**DGEIS FINAL SCOPE OF WORK AND REASONABLE WORST CASE
DEVELOPMENT SCENARIO**

Fresh Kills Park

Final Scope of Work to Prepare a Generic Environmental Impact Statement

C. RESPONSE TO COMMENTS

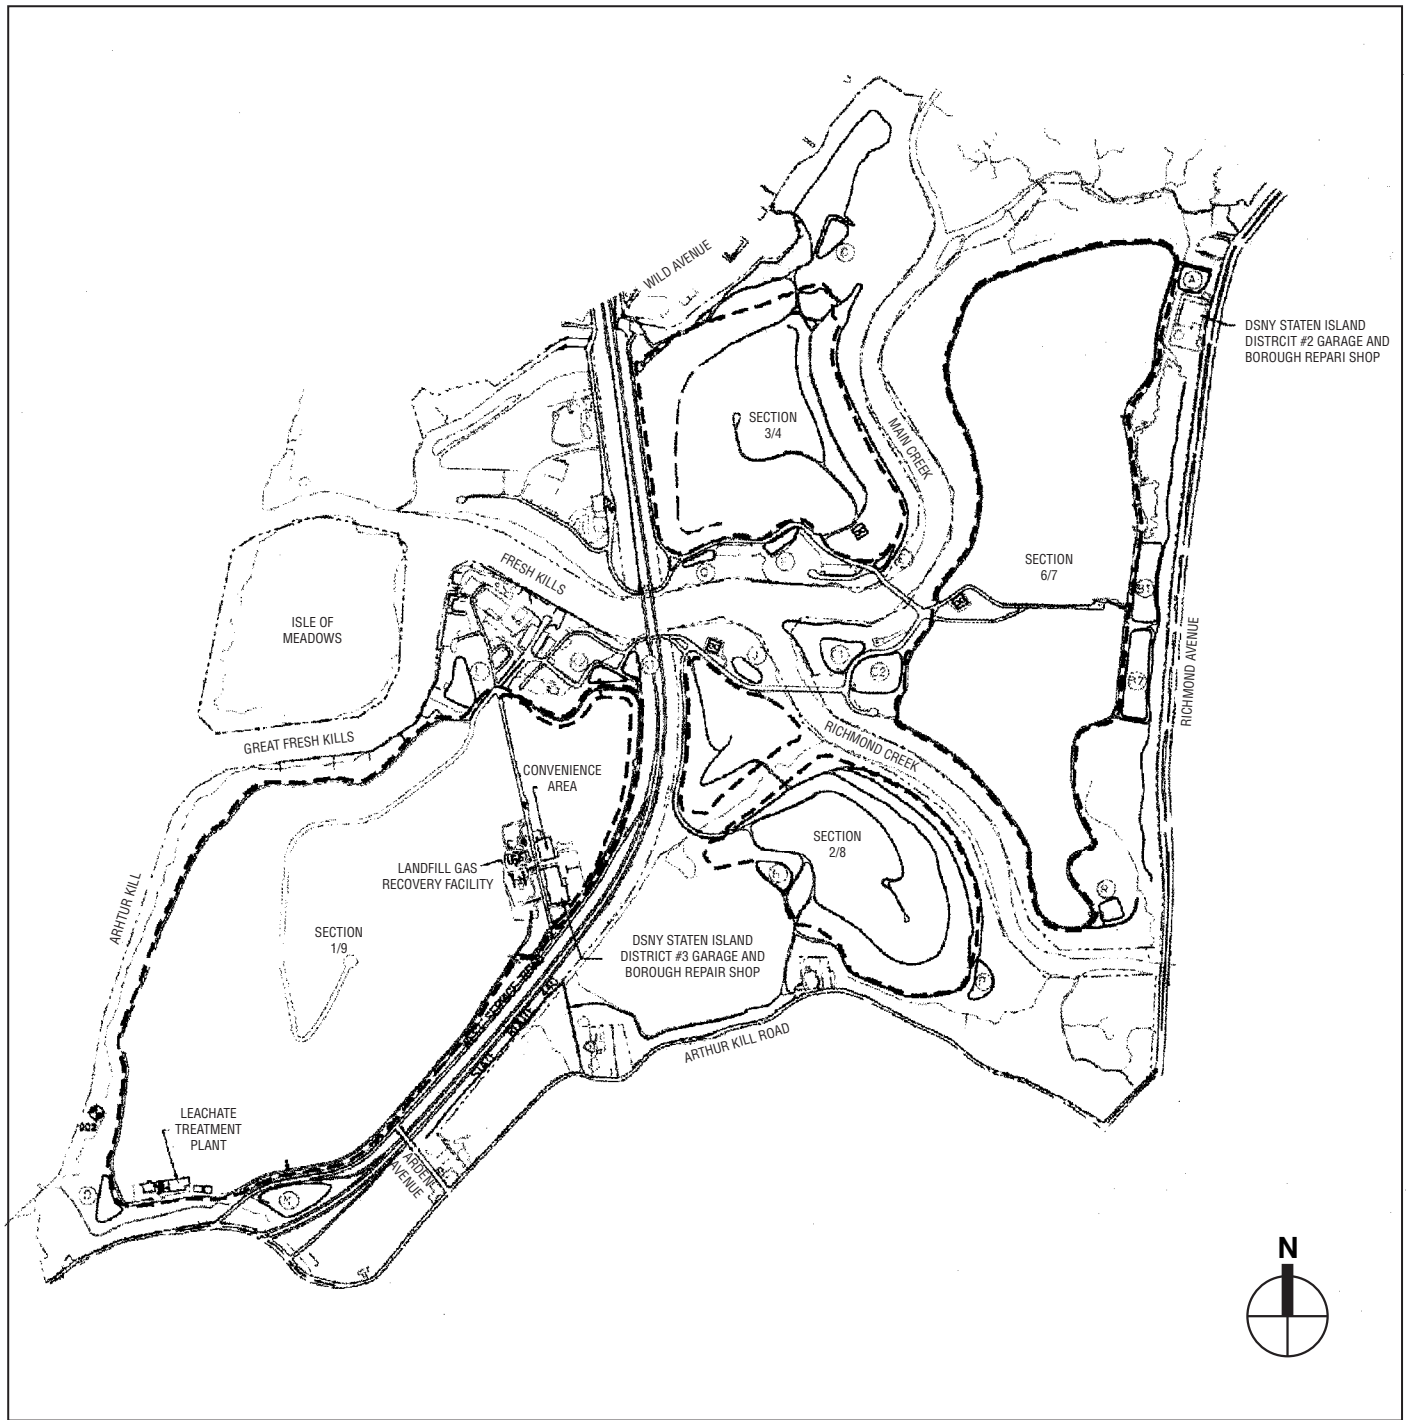
Comment 29: Figure 2: the “Solid Waste Management Unit Boundary” that encompasses Old Muldoon at Section 1/9 and the Landfill Gas Recovery Facility should be deleted. Both the LFG recovery facility and the “Old Muldoon” portion of Section 1/9 as well as District 3 garage are within the “Solid Waste Management Unit Area.” (2)

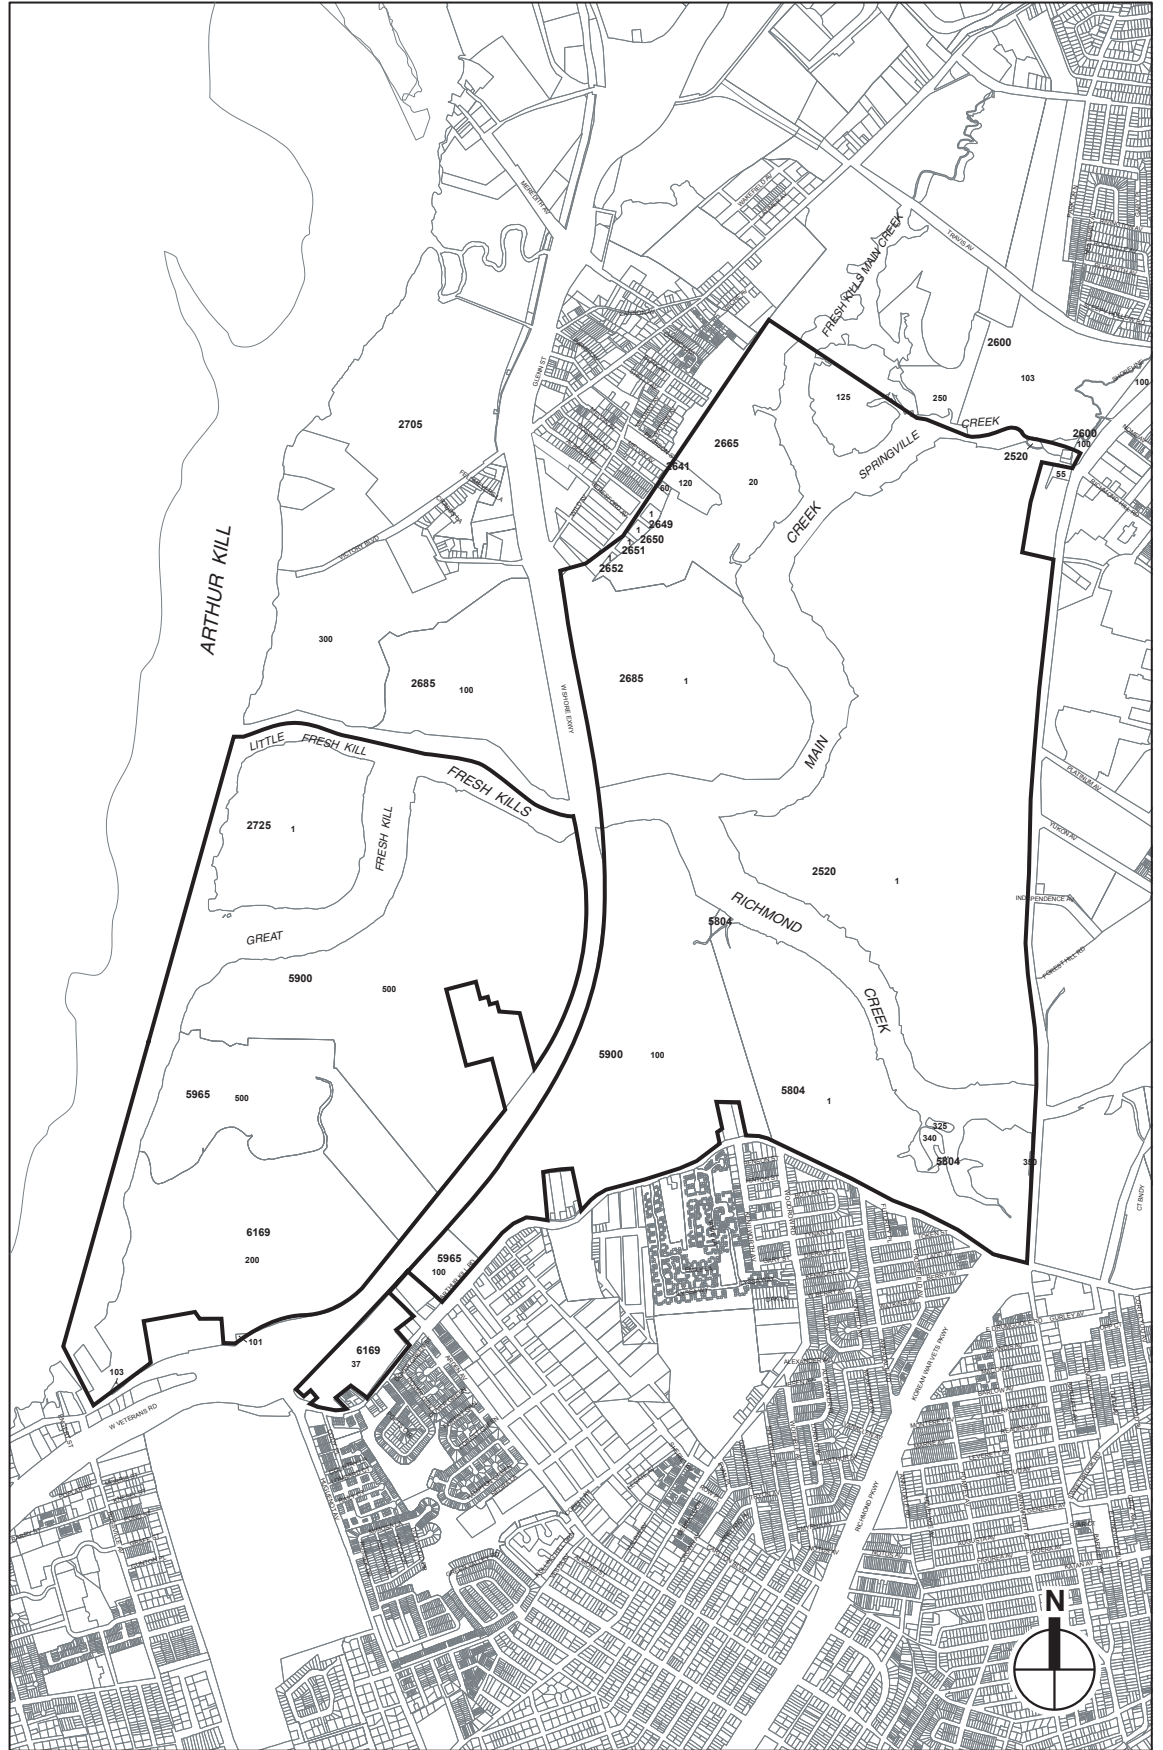
Comment 30: Figure 3: Confirm boundary of the tax parcel; is it the northern edge on the shoreline of Fresh Kills Creek? The park is not proposed to include this shoreline. (2)

Response: Figure 3 has been amended to be consistent with the park mapping noted on Figure 7.

FRESH KILLS PARK, MASTER PLAN REASONABLE WORST CASE DEVELOPMENT SCENARIO PROGRAM INTENSITY ZONES

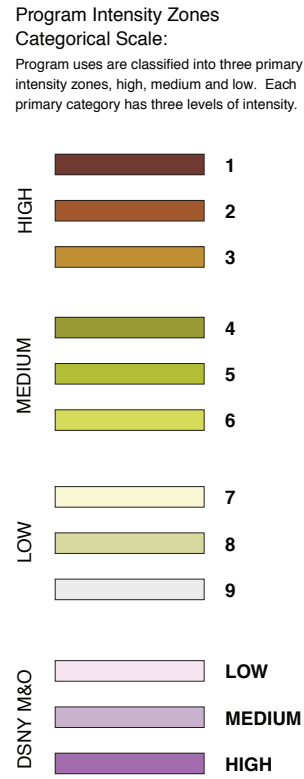
Comment 34: Figure 4: We note that certain DSNY maintenance and operation areas are indicated within the proposed park boundaries. The Plan/GEIS should also recognize in the text and accommodate DSNY’s need for facilities to manage the post closure care operations and maintenance within park limits beyond what has been identified in Figure 4. (2)

Comment 59: In Figure 4, the area identified as "Habitat without People" is difficult to discern. The GEIS should consider that for these locations to function as natural areas they need to be as large as possible, contiguous with other varied habitats, and as secluded from areas of activity as possible. (1)

Response: The Final Master Plan and the GEIS will recognize DSNY's need for facilities to manage landfill post closure care operations and management within park limits, beyond the facilities that have been identified as outside the proposed park on Figure 4. The GEIS will also examine the development and operation of the proposed park and its compatibility with these DSNY facilities.

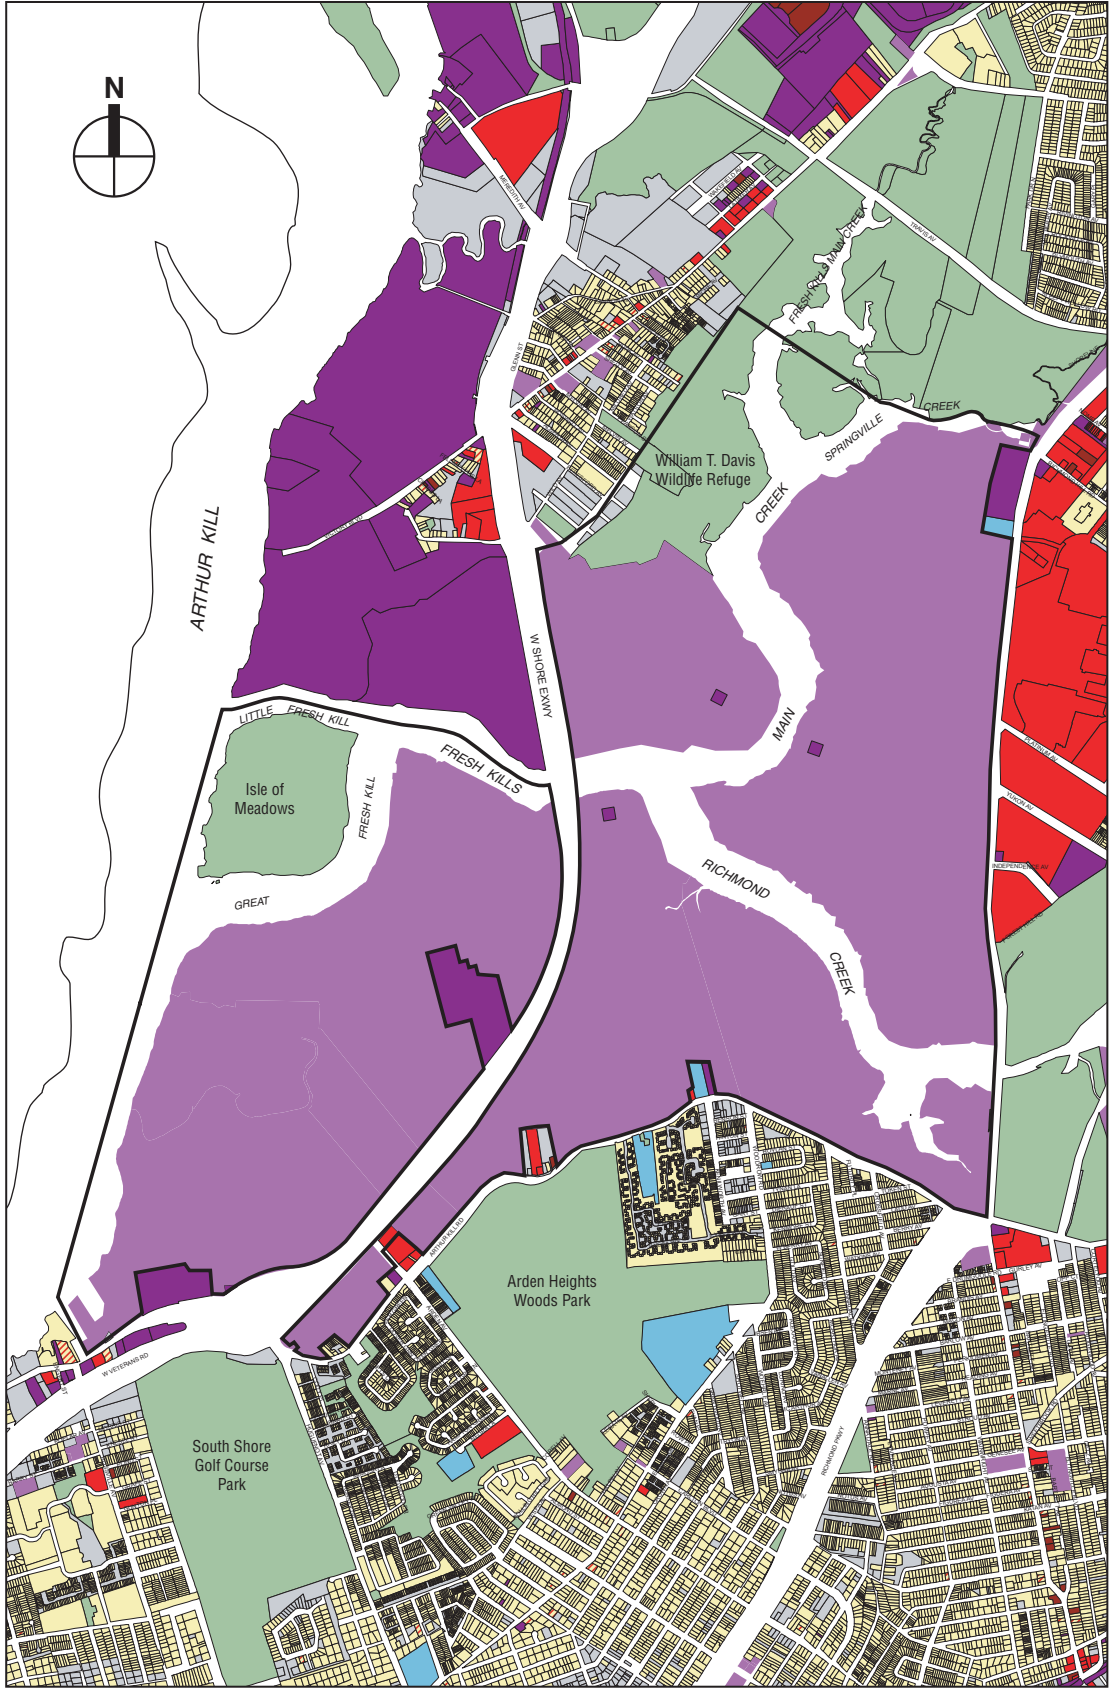
Comment 50: Figure 8: The NYPD substation on Richmond Avenue does not appear to be reflected. (2)

Response: This change has been made to Figure 8 in the scope of work.

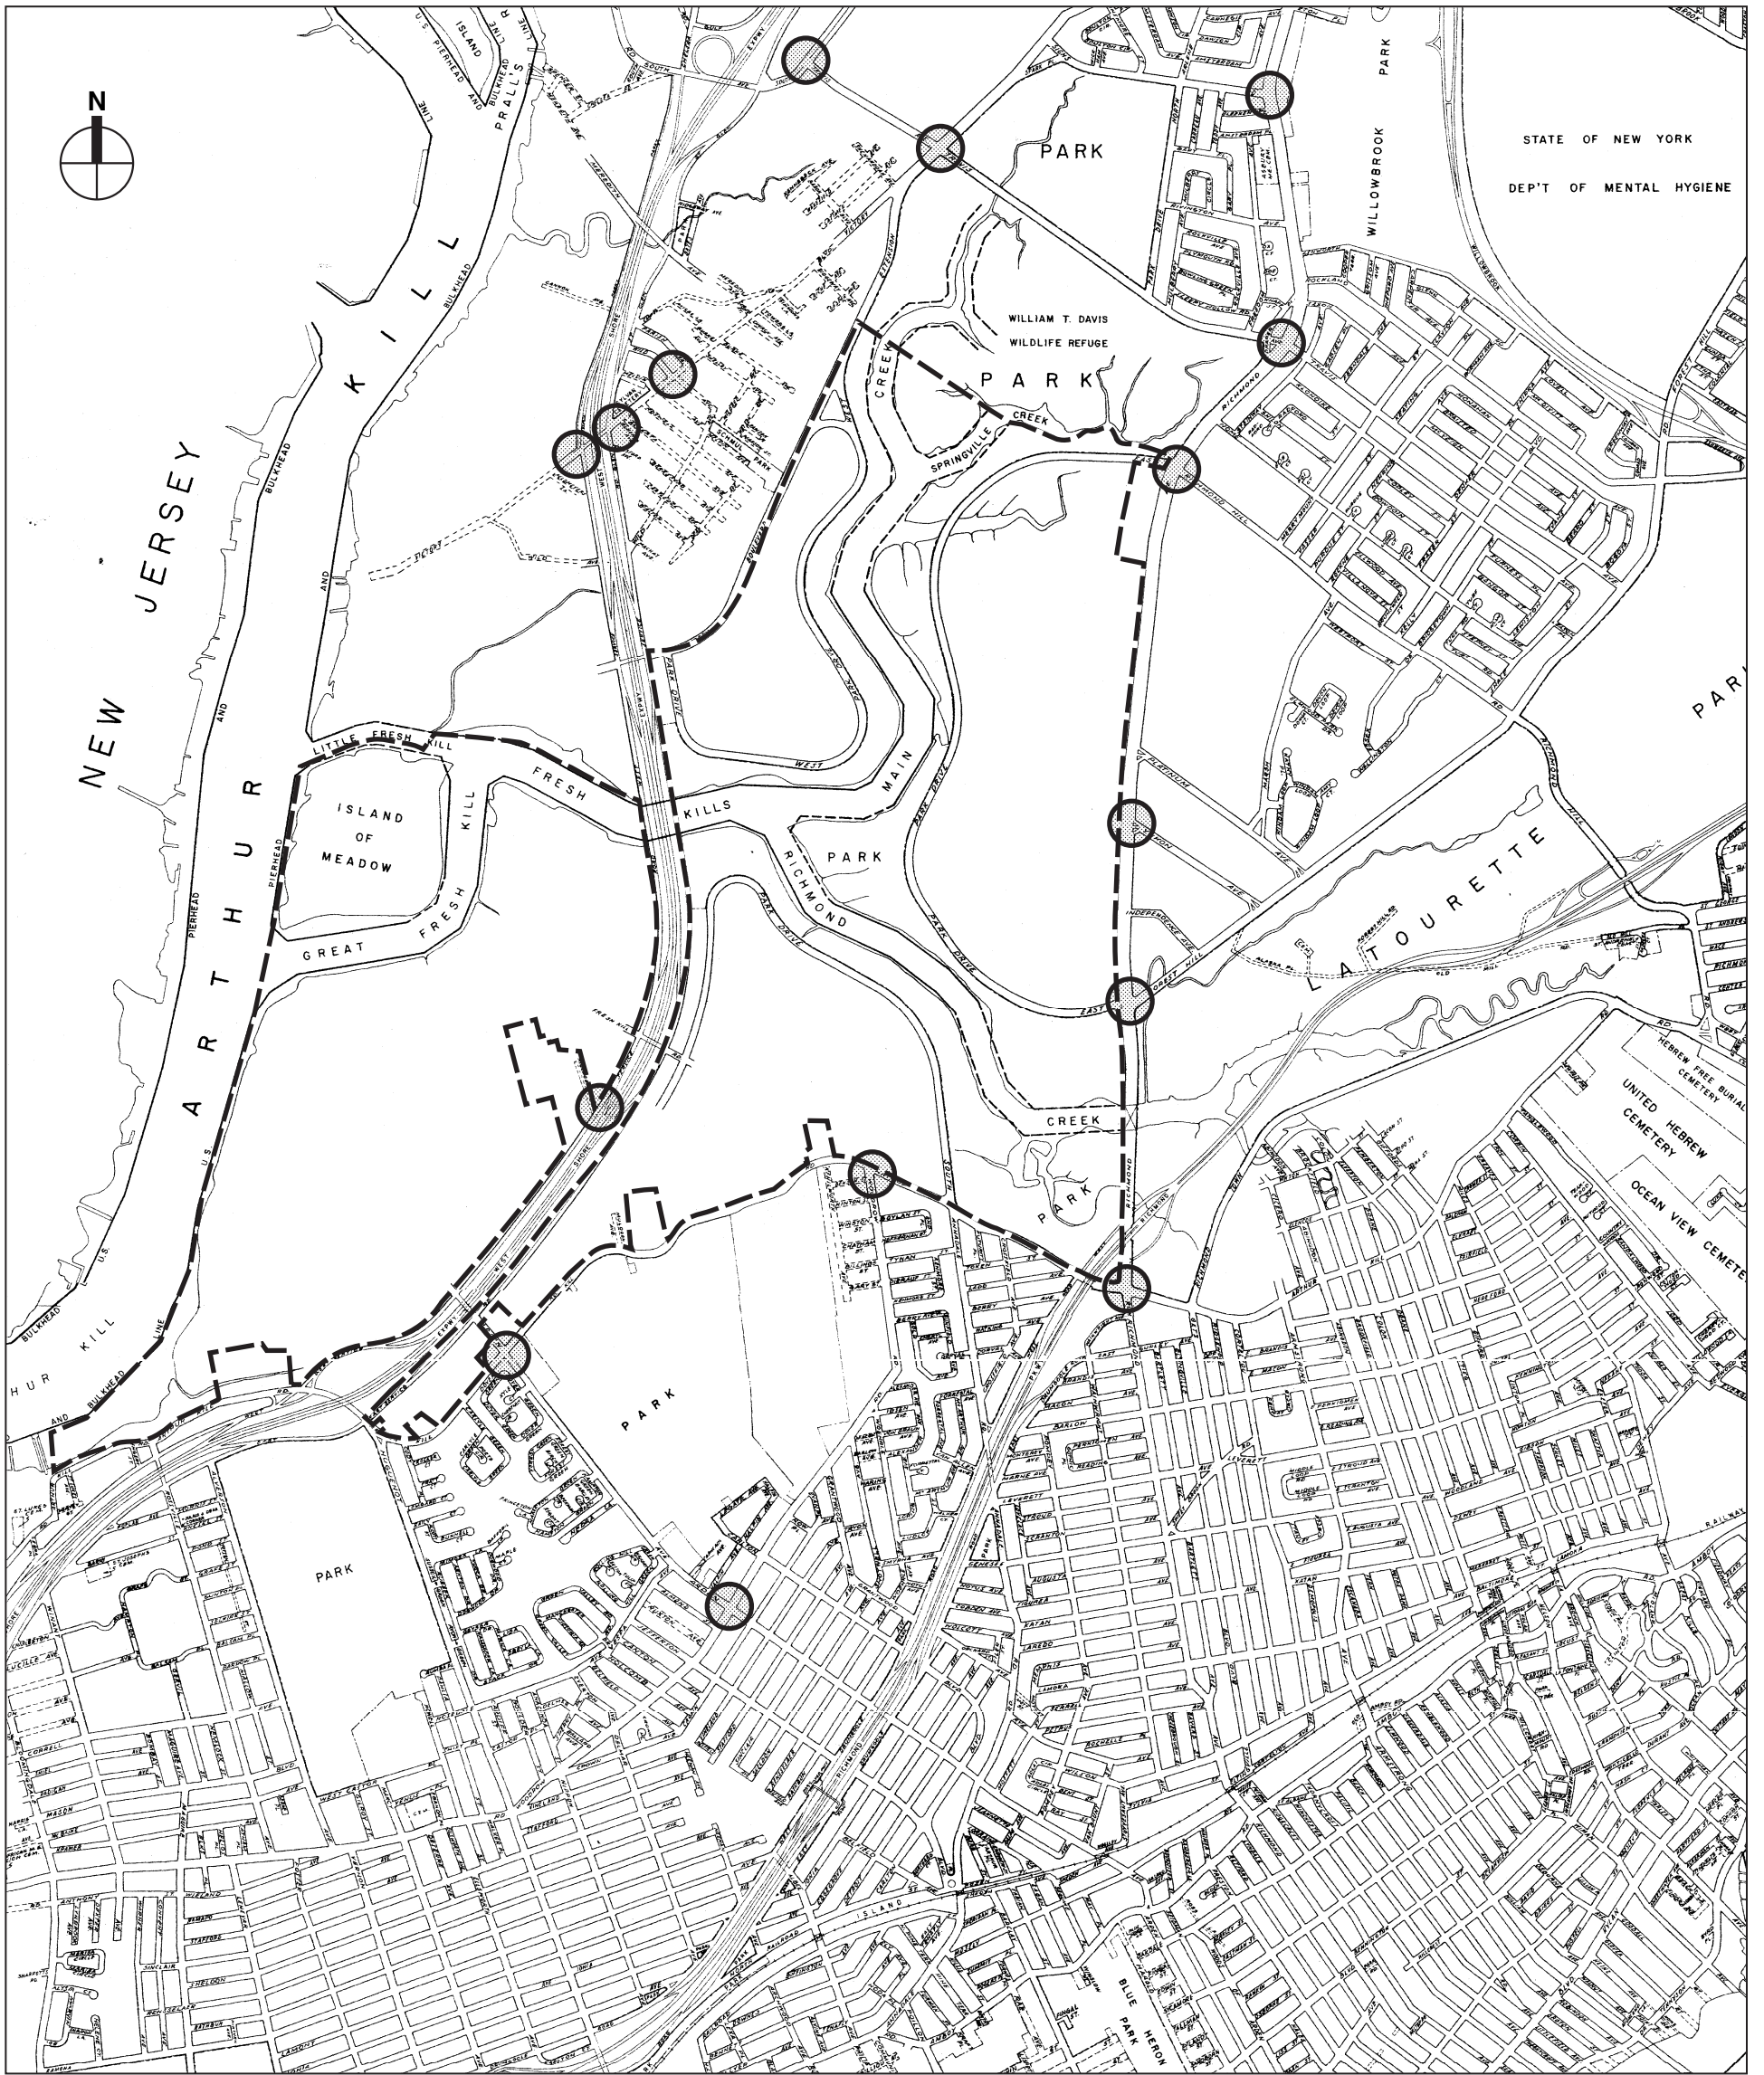
roadway configuration. Currently, the scope of work includes a total of 30 intersections as well as 8 ramp connections with the West Shore Expressway (see Figure 11), with weekday and weekend analyses. If, during the preparation of the “Transportation Planning Factors” memo, it is determined by NYCDOT and/or NYSDOT that additional intersections are necessary for this analysis, those intersections will be analyzed in the DGEIS.
